Special Bulletin

SP21-82

FLOOR SIDE FLAT BAR

B13R (9700 us/can)

FIGURE 1

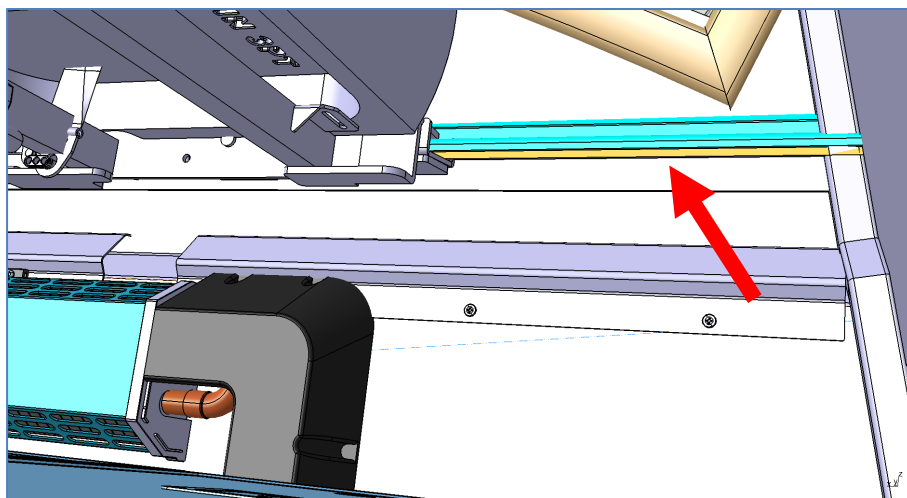
1. Install a flat bar (P/N: 24144641) on the linoleum top end.

FIGURE 2

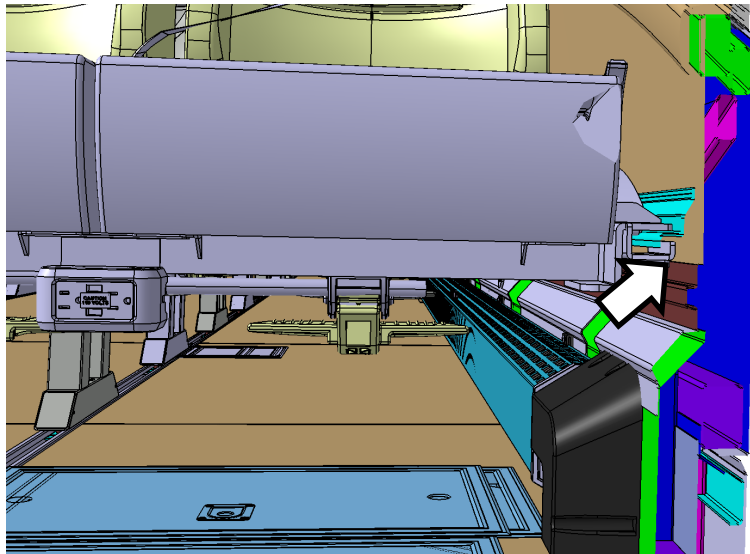
2. Location of the flat bars (P/N: 24144641) along the side wall is behind to seat rail aluminum profile.

FIGURE 3

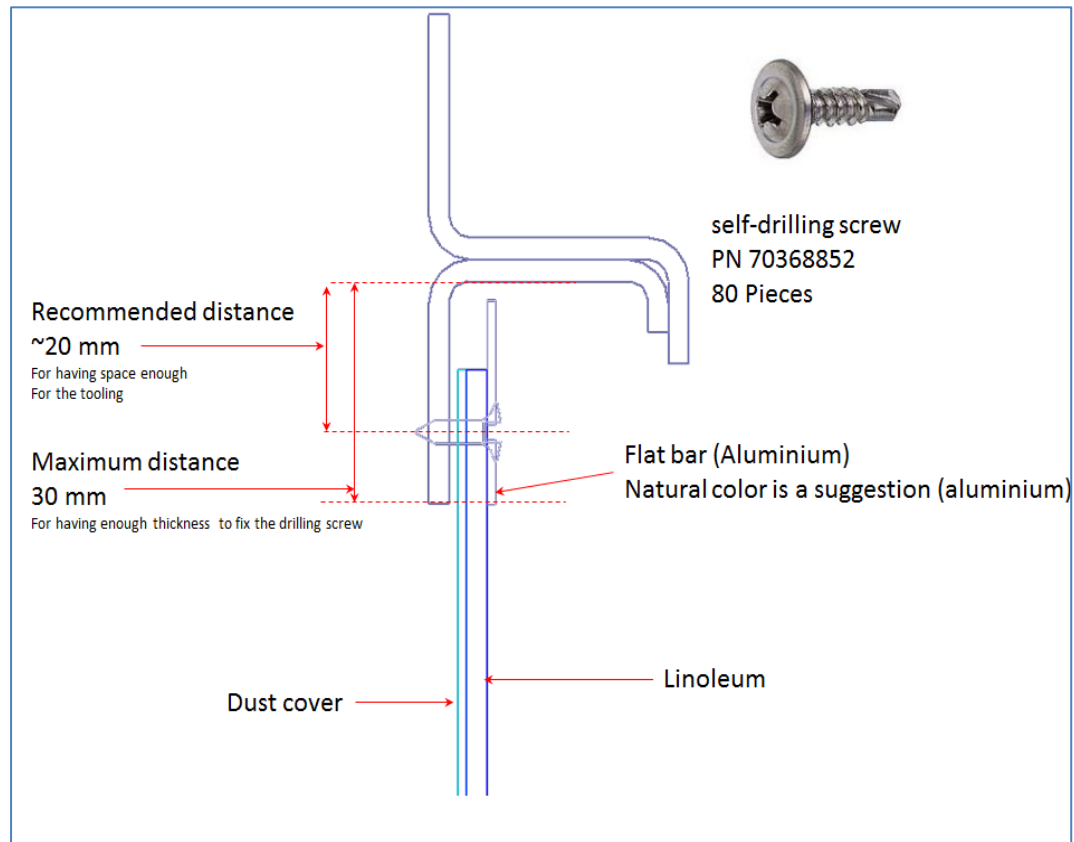
Each flat bar should be screwed using a CROSS RECESSED SUNK SCREW (*P/N: 70368852*) according to dimensions recommended at **FIGURE 3**.

Each flat bar contains 4 drilling guides. Secure the flat bar with 4 CROSS RECESSED SUNK SCREW.

FIGURE 6 FLAT BARS INSTALLATION AT THE LEFT-HAND SIDE.

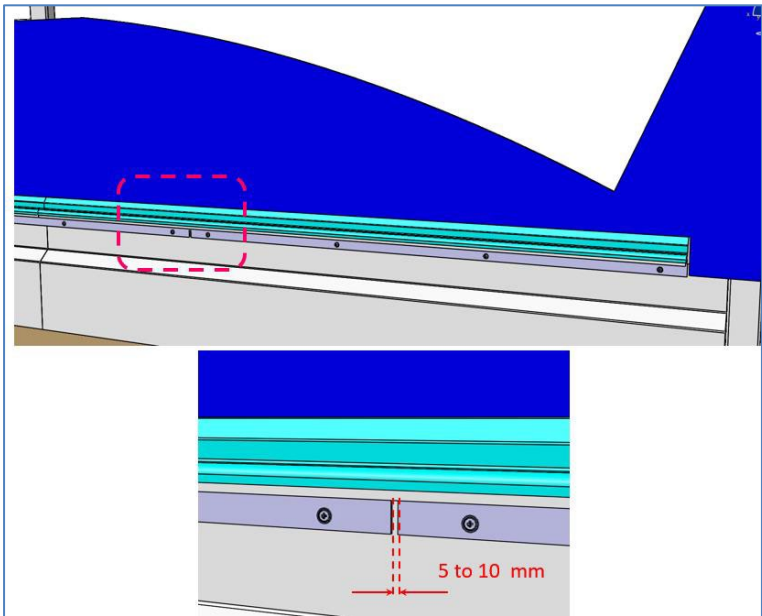
Note: Consider a separation of **5-10 mm** (Figure 6) between them of on the left side for a better distribution of the supports along the bus.

Figure 9

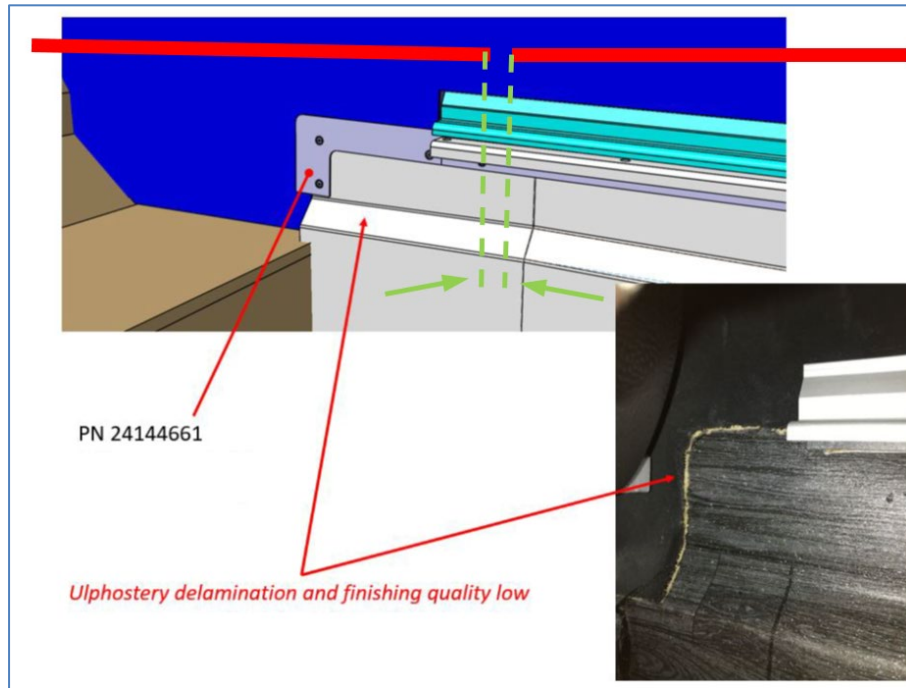
4. An additional molding (*P/N: 24144661*) will be added (*only for the back corner, on the left side*) to improve the quality of the finish.

The additional molding should be screwed as shown at the **FIGURE 9** using 4 CROSS RECESSED SUNK SCREW (*P/N: 70368852*).
